Smart Inverter Working Group

Topic E: Implementation of Limited Generation Profiles Using Current Smart Inverter Functions

Overarching Framework Discussion For Section C

3.a,b
Apply Screen A-L and New Screen F1(OP 5) and queue assignment as may be applicable based on Nameplate

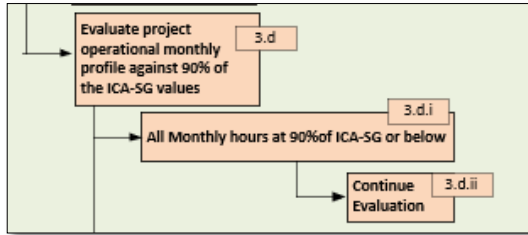
Step	Resolution Question	IOU Response
3.d.i	3) the Large IOUs state that if the export request for each of the 12 months is at or below the 90% of each month's minimum ICA-SG value then the project can continue with its evaluation. This step shall be updated as needed based on discussions related to Resolving Issue 2.	The IOUs will compare each hour of the customer's proposed LGP profile with 90% of the ICA-SG profile. The IOUs will update this step as needed based on discussions related to Resolving Issue 2 (Use of Gross Nameplate Rating)

3.d.ii	4) the Large IOUs state "If all Initial review screens (A-L) are met including 3.d.i (all requested values are below 90% of each month's ICA values)" then the project will pass the Rule 21 Fast Track screens. This step shall be updated as needed based on discussions per Resolving Issue 2.	<ul style="list-style-type: none"> The IOUs will update this step as needed based on discussions related to Resolving Issue 2.(Use of Gross Nameplate Rating)

Phase 5. Operation Performance Phase:

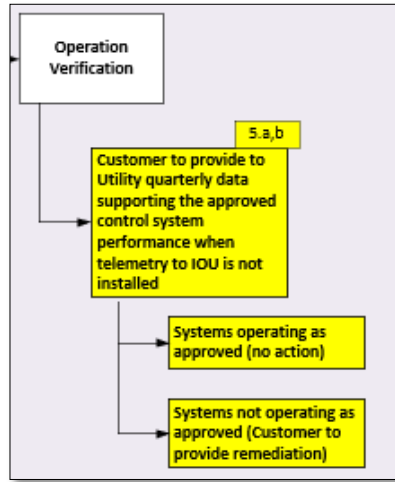
Step	Resolution Question	IOU Response
5.a.	1) The Large IOUs shall clarify whether they are seeking to impose this as a requirement, or if the Large IOUs are merely reserving the right to implement this step. ... If seeking to impose this as a requirement, the Large IOUs shall provide an estimate of the scope of backend system and infrastructure expansion required in the subsequent AL, costs associated with it, and estimate the length of time required for full deployment of these systems to provide to the Commission information on potential scale of such work.	This topic is no longer necessary, IOUs agree to use AMI data in combination with telemetry (for Generating Facilities ≥ 1MW) to verify performance.
5.b	2) the Large IOUs require customers to provide quarterly reporting data. The Large IOUs shall update this step based on the outcome of the discussions set forth in this Resolution

Topic no longer necessary
